BID ADDENDUM NO. 8

October 22, 2018

Johnson Student Center
Building Demolition, Increment 1 (Demolition) and Increment 2

RANCHO SANTIAGO COMMUNITY COLLEGE DISTRICT
SANTA ANA, CA

3 SECOND FLOOR RESTROOMS (WATER & GAS)
SCALE: 1/4" = 1'-0"

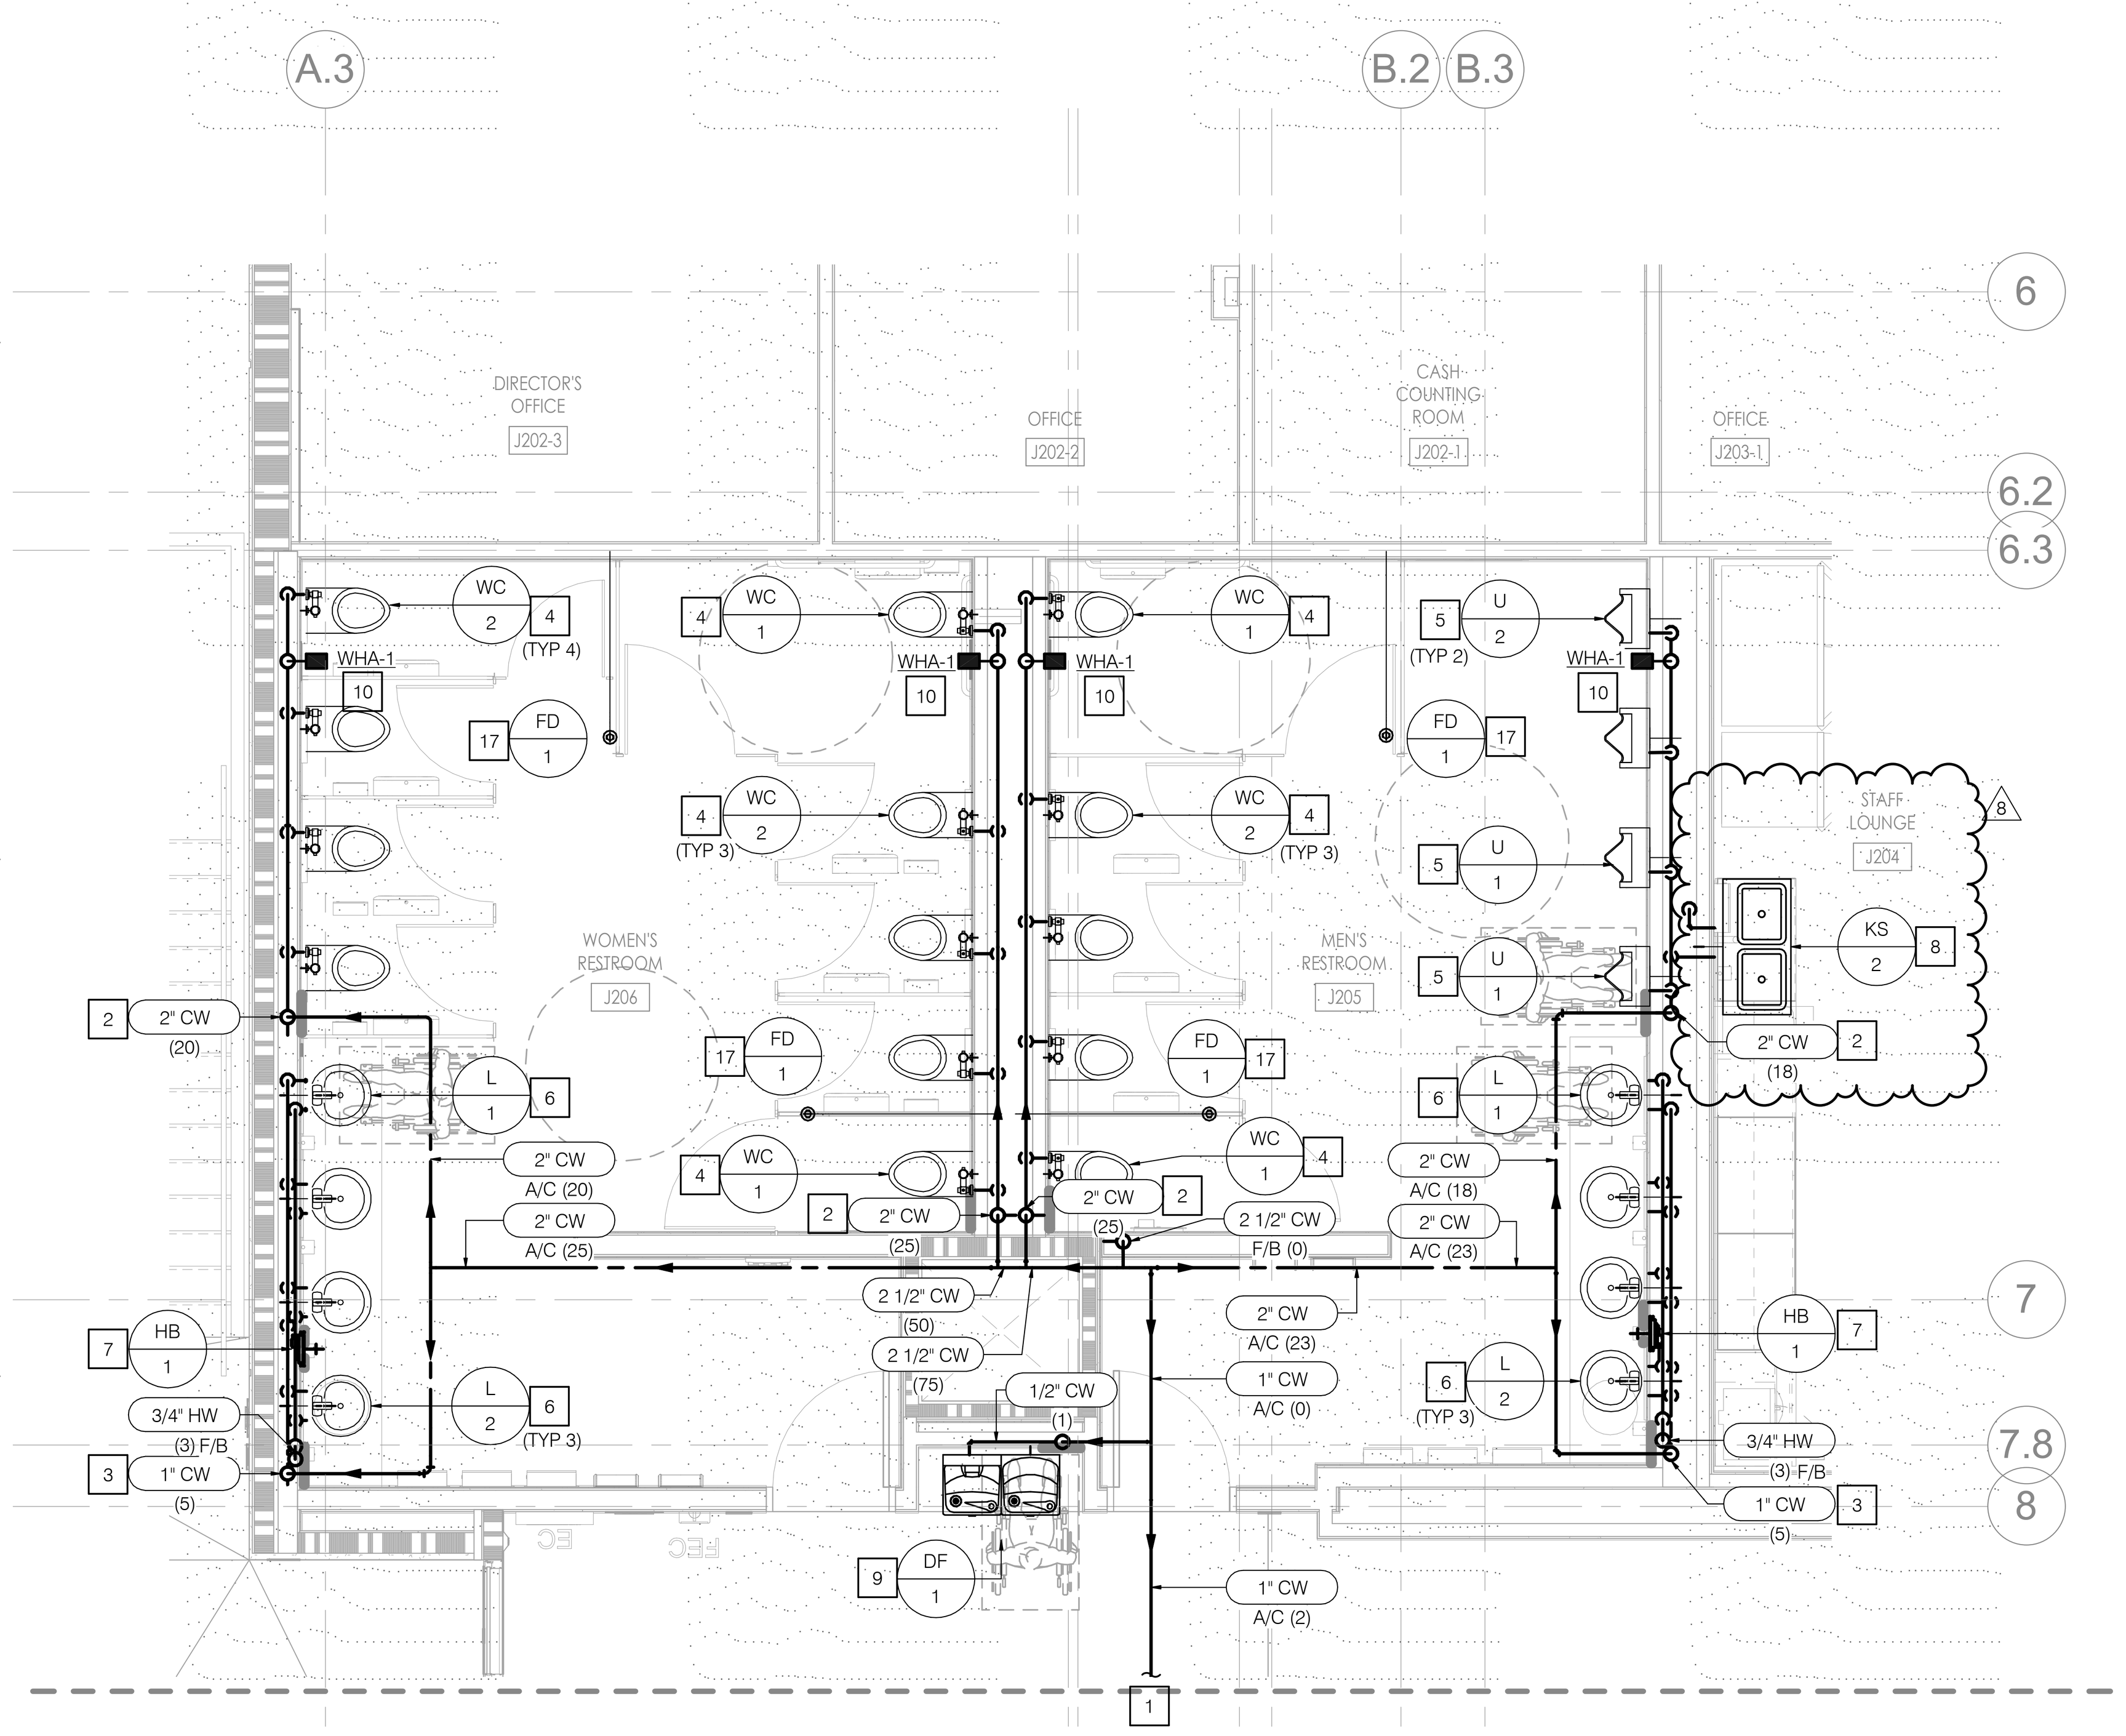
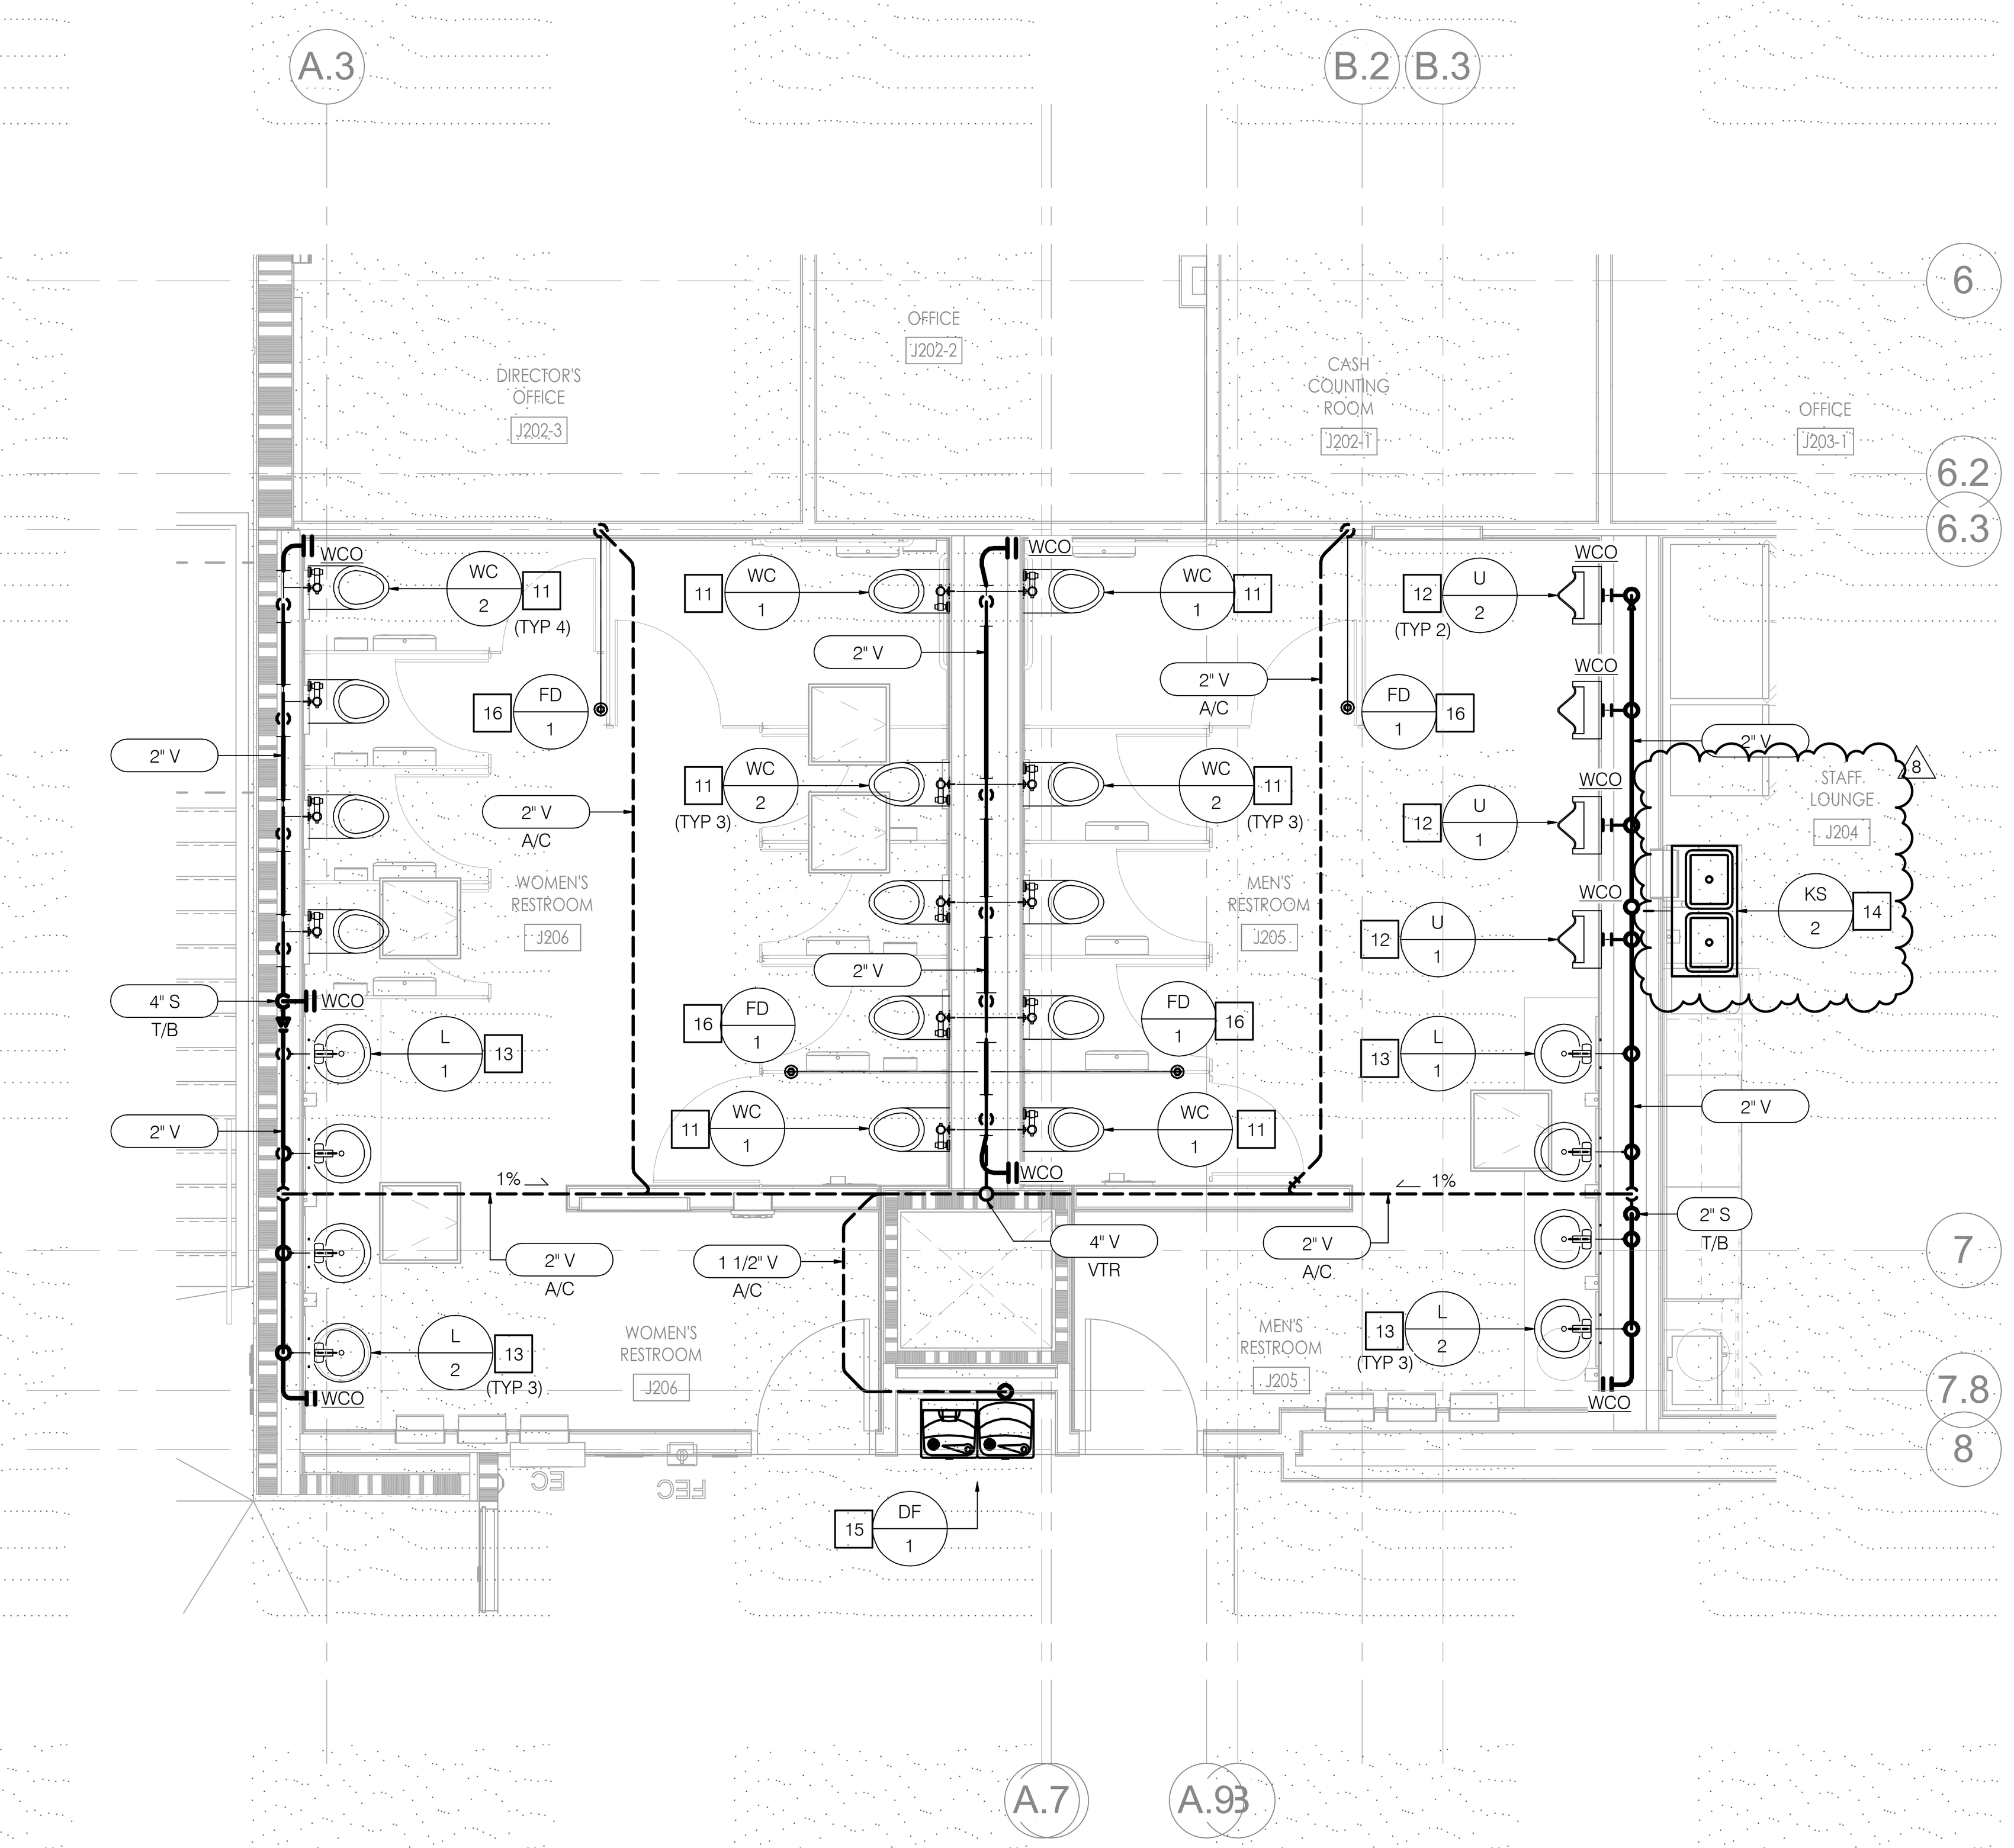
Plumbing/Electrical:
  - Increment 2: Revised single sinks to double sinks with garbage disposals. Refer to attached cutsheets KS-1, KS-2 and revised sheets P0.02, P2.12, P2.22, P3.03, E0.03, E0.11, E2.21.

PMF Series 32"/43"/49"/55" digital signage

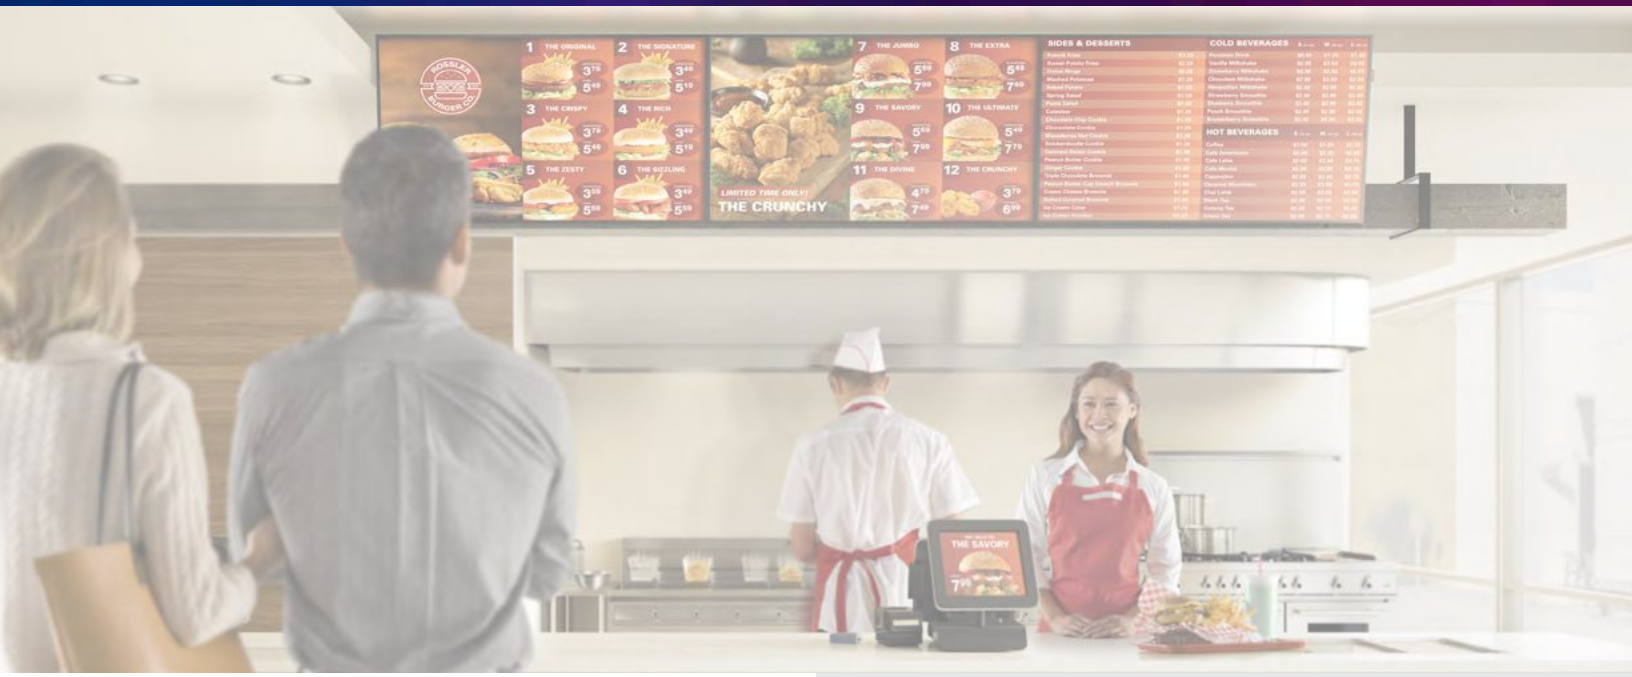
Increment #2 -
E2.13 indicates the North Lobby J200-1 to have a "Flat Panel Display" (Keynote 22) near gridlines C.1 & 3 while gridlines 5 & B.8 should be "Digital Signage" (Keynote 23). Spec section 274116-1.3D provides dimensions for Informational displays and Digital Signage and provides two different dimensions while LV1.21 calls out these two displays with the same detail (5/LV5.21) indicating they are to be the same dimensions (which is different than the dimensions in the specs). Please clarify which type of signage and the dimensions of the displays should be provided at each location.

At the 2 other "Flat Panel Display" (Keynote 22) locations detail 3/LV5.21 is called out. Please confirm that these 2 locations are Informational Display signage which is 55" per spec 2741161.3D.

All displays detailed with LV5.21/5 are portrait-oriented 43" Samsung PM43F w/ embedded digital signage player (or current equal); spec sheet attached

All displays detailed with LV5.21/3 are landscape-oriented 55" Samsung PM55F w/ embedded digital signage player (or current equal); spec sheet attached
